**AN AMENDMENT TO THE  
MASTER DRAINAGE DEVELOPMENT PLAN  
FOR  
WATERVIEW**

# **WATERVIEW NORTH**

EL PASO COUNTY, COLORADO

June 2020

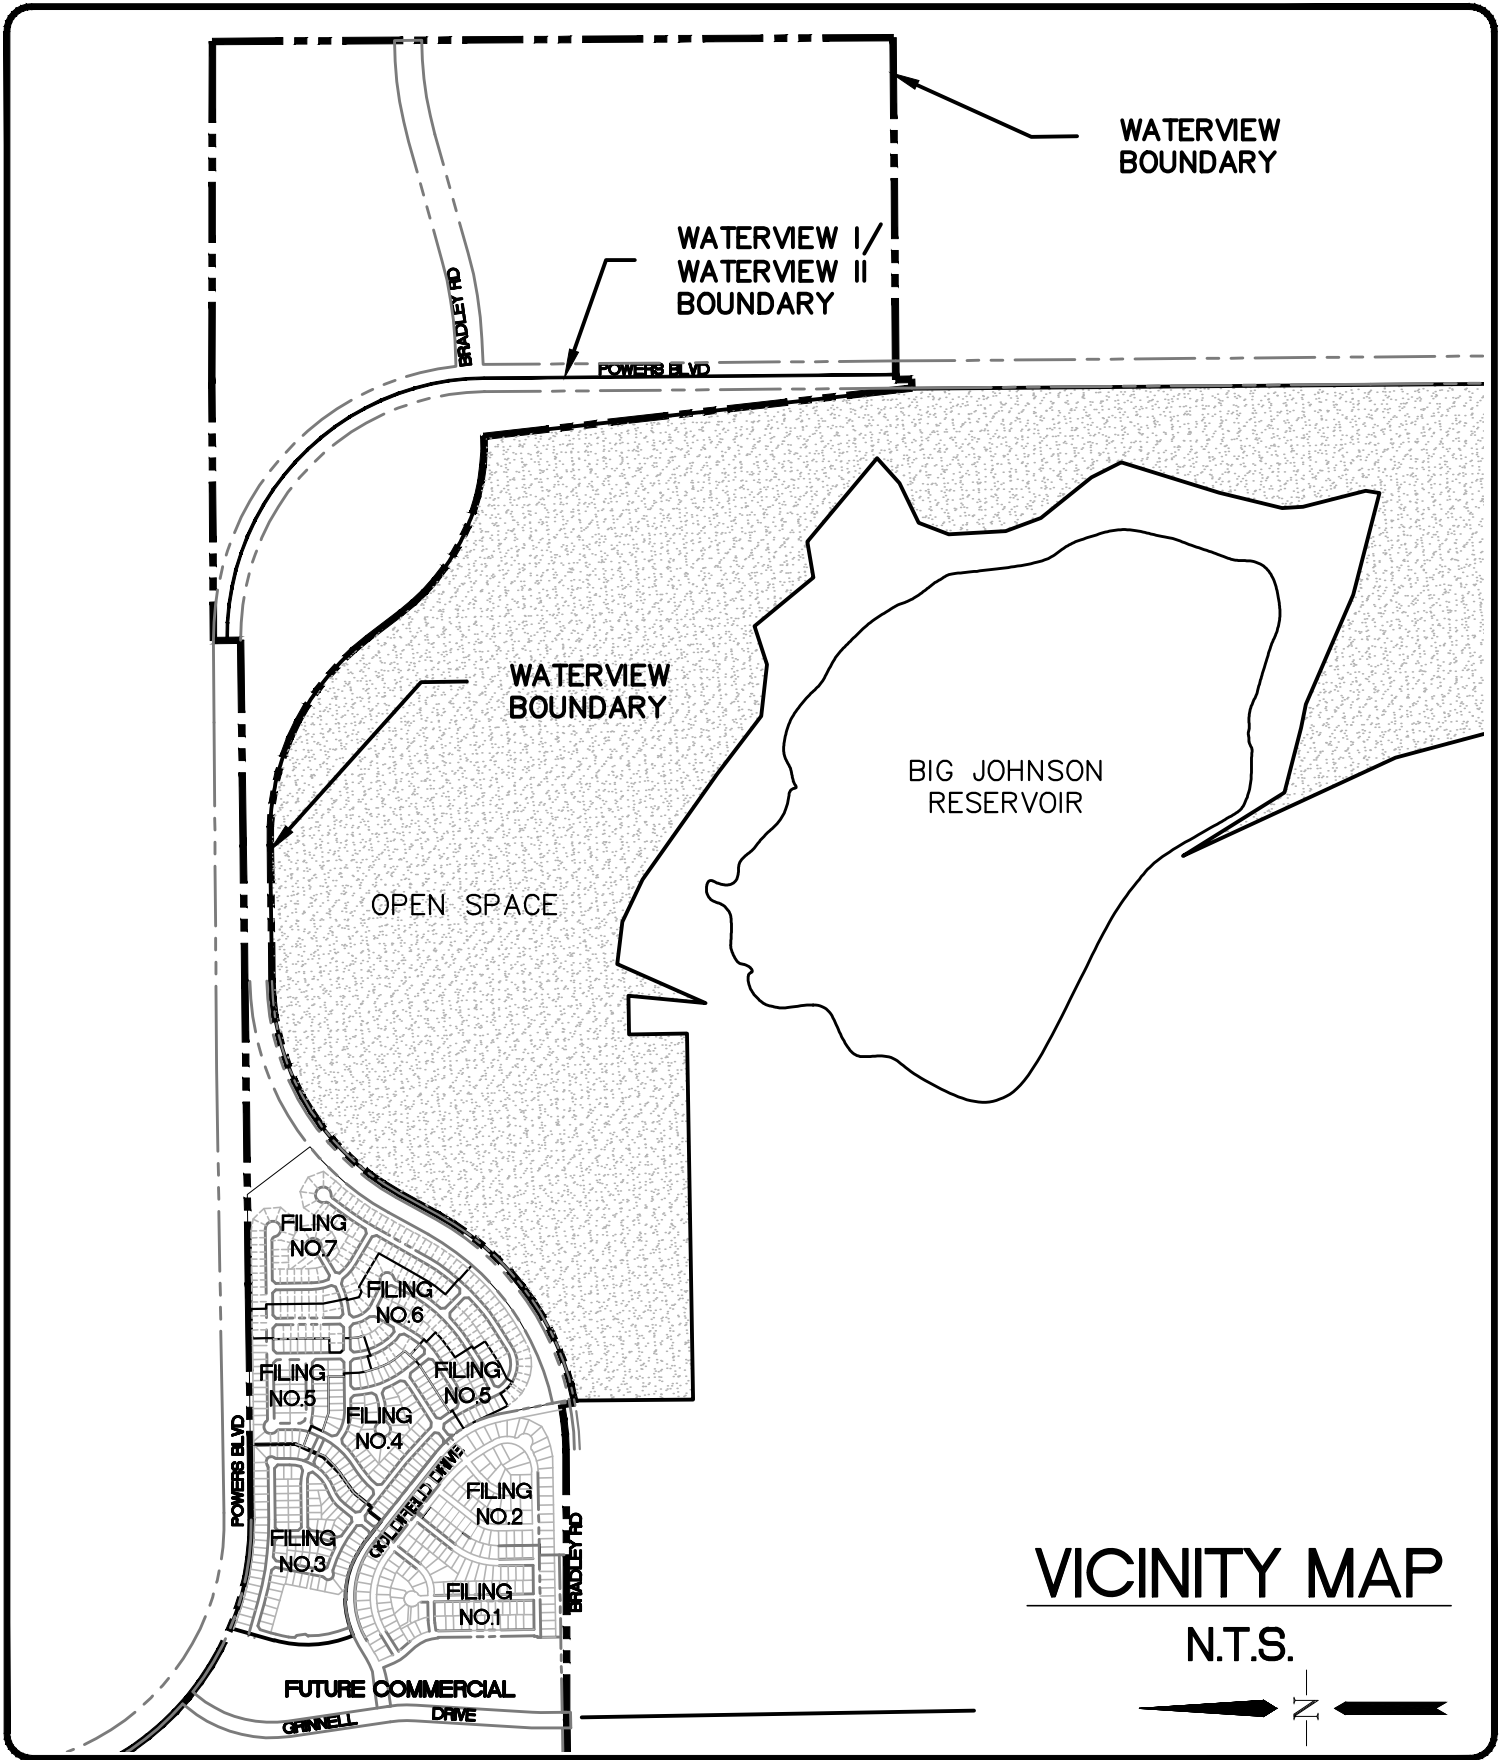
what is the anticipated width of the spreader?

Add a statement that the diversion channel design will include access roads meeting ECM Section 3.3.3.K.1. State whether or not the channel is anticipated to be placed in a tract or a drainage easement? Restrictions for no build, no storage of material and no fencing will be placed on the drainage easement containing the diversion channel.

Subcatchment Name	Percent Imperviousness (%)
BJD-12b	5

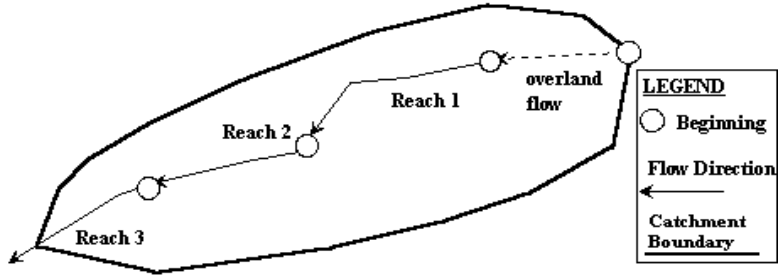
Revise. % impervious is high for per-development.

## Routed Hydrograph Results

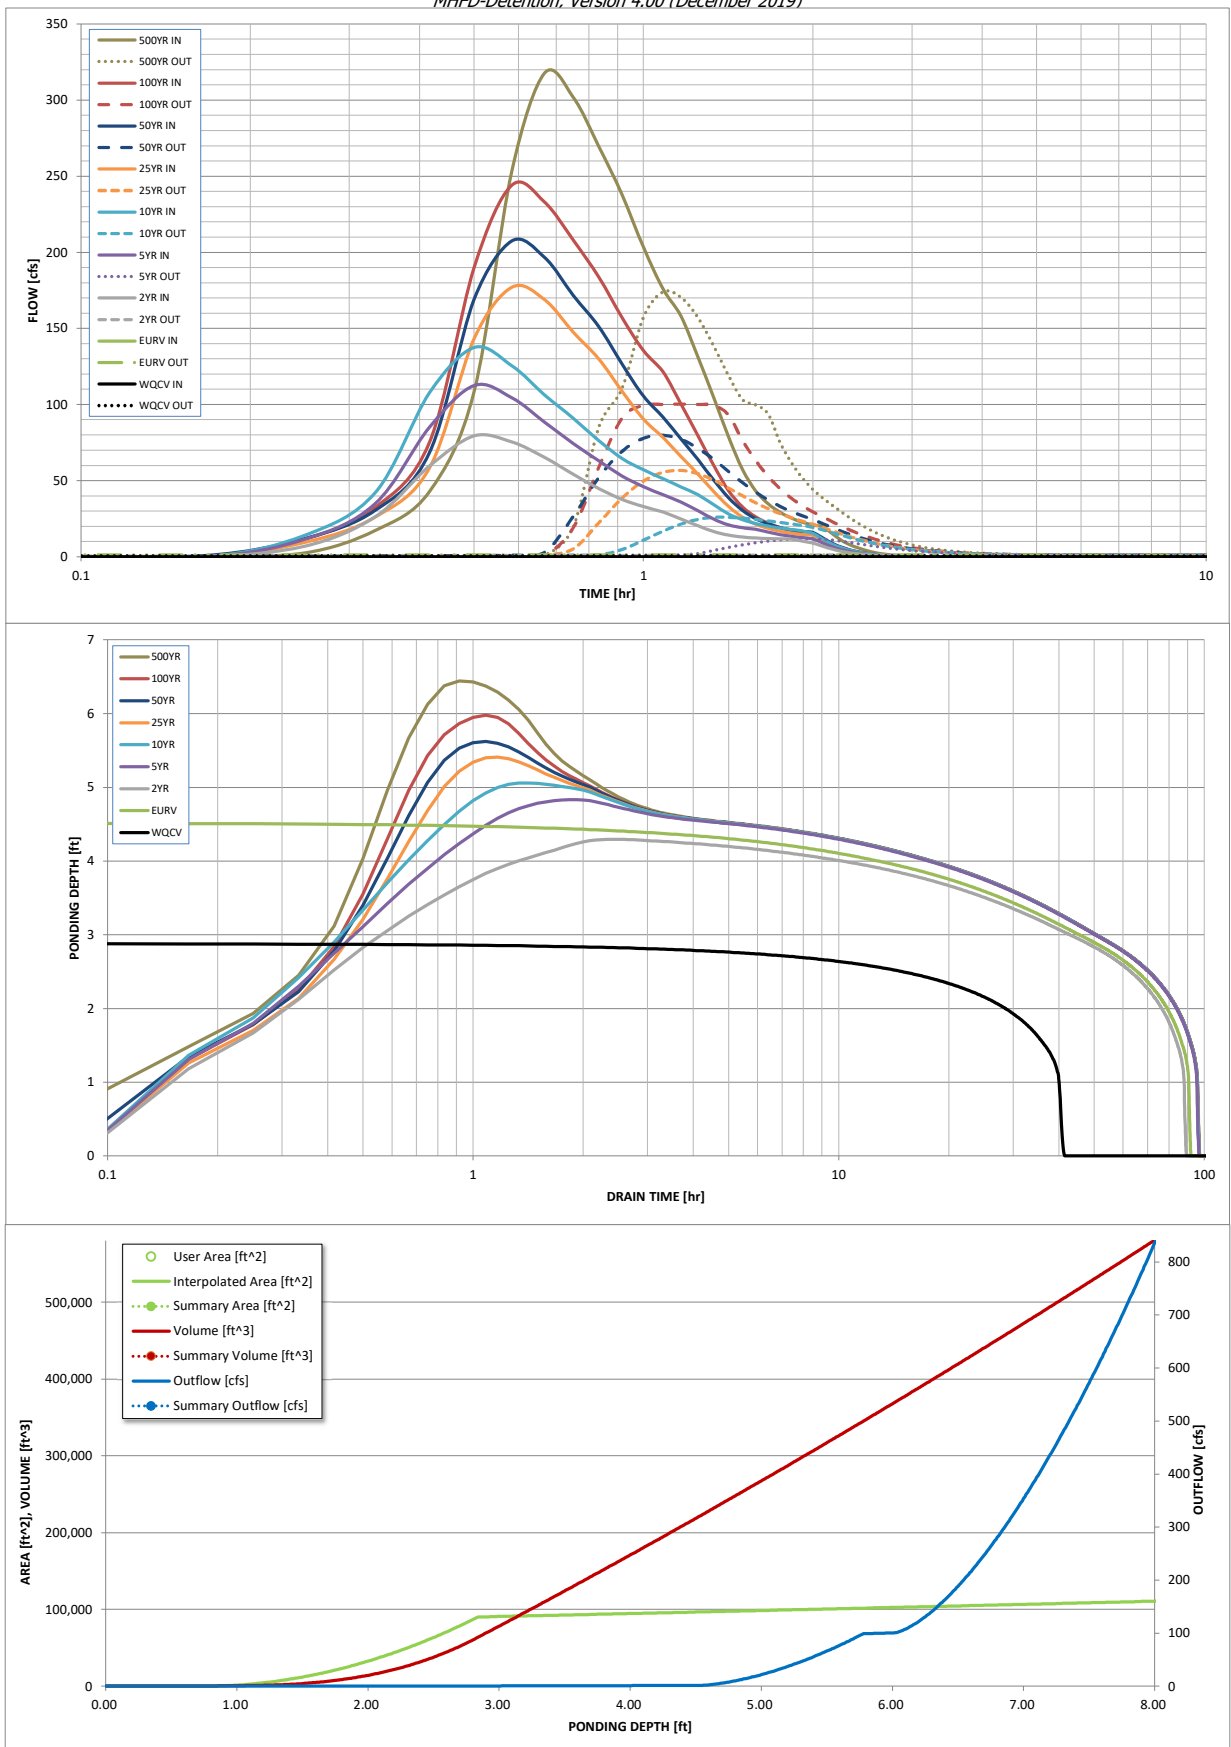
On the FDR outlet structure will need to be revised to drain the 2yr and 5yr design storm within 72hrs.

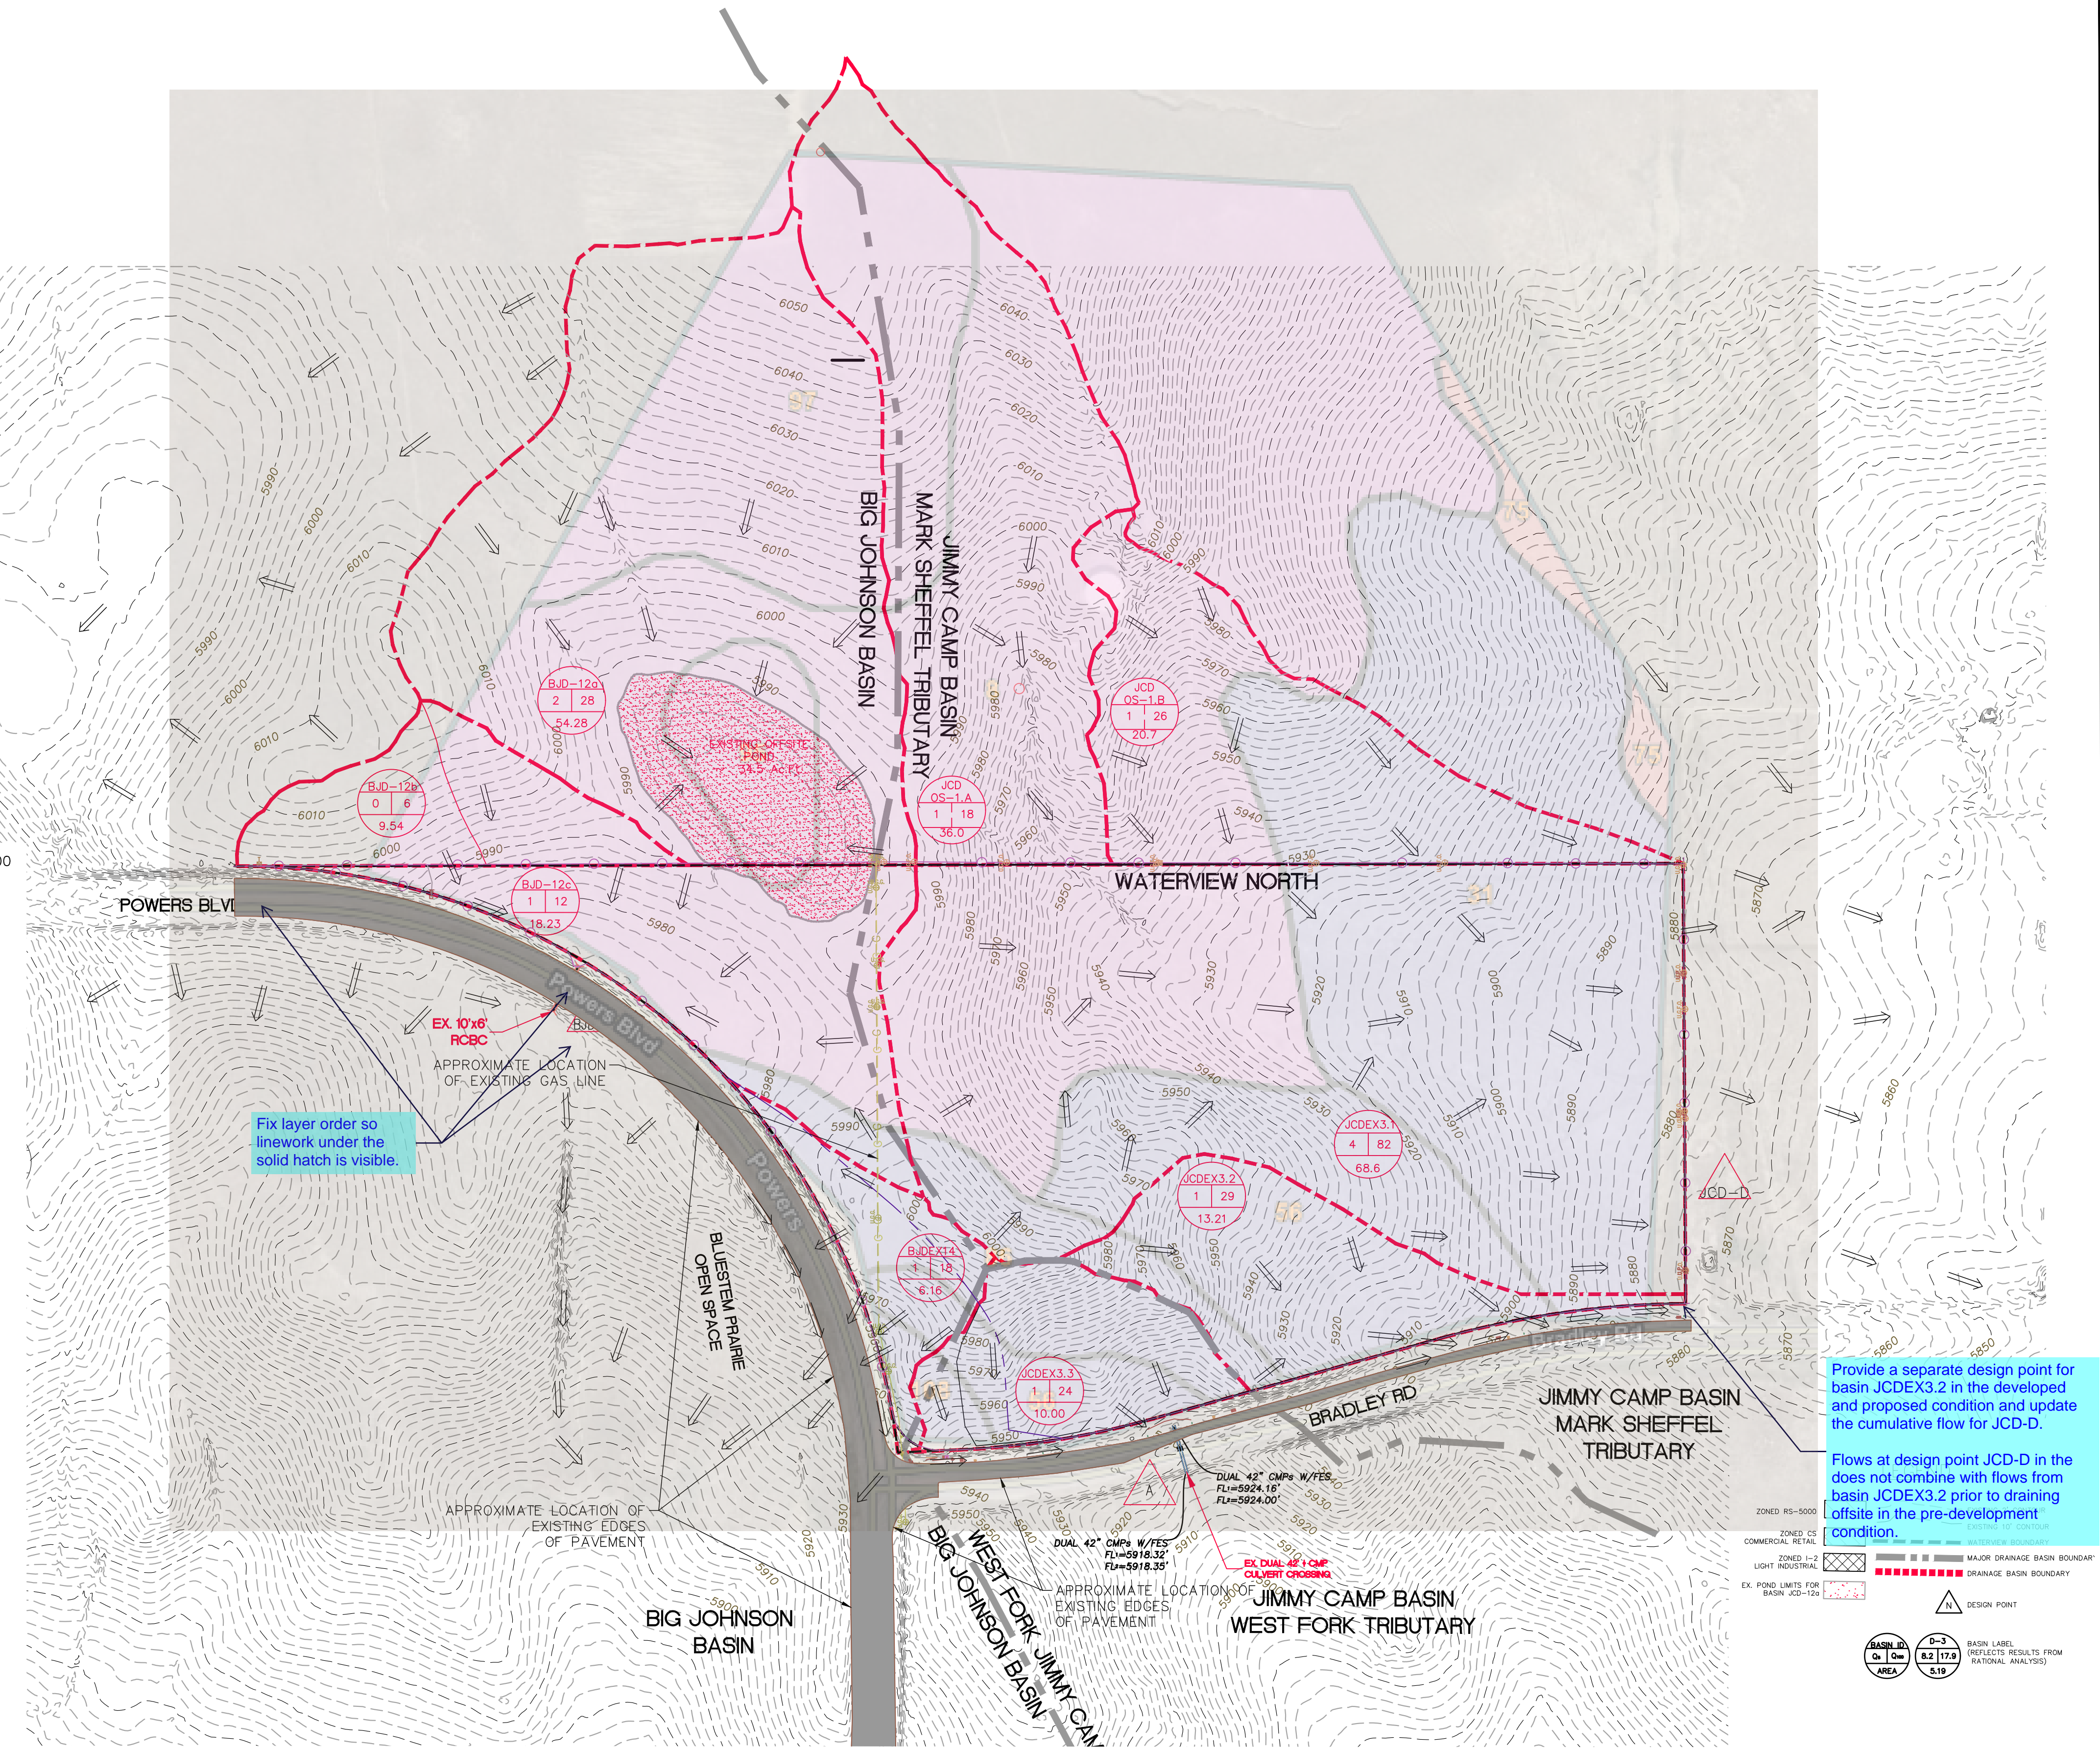
Revise. Reference must be from the FDR.

Provide a separate design point for basin JCDEX3.2 in the developed and proposed condition and update the cumulative flow for JCD-D.
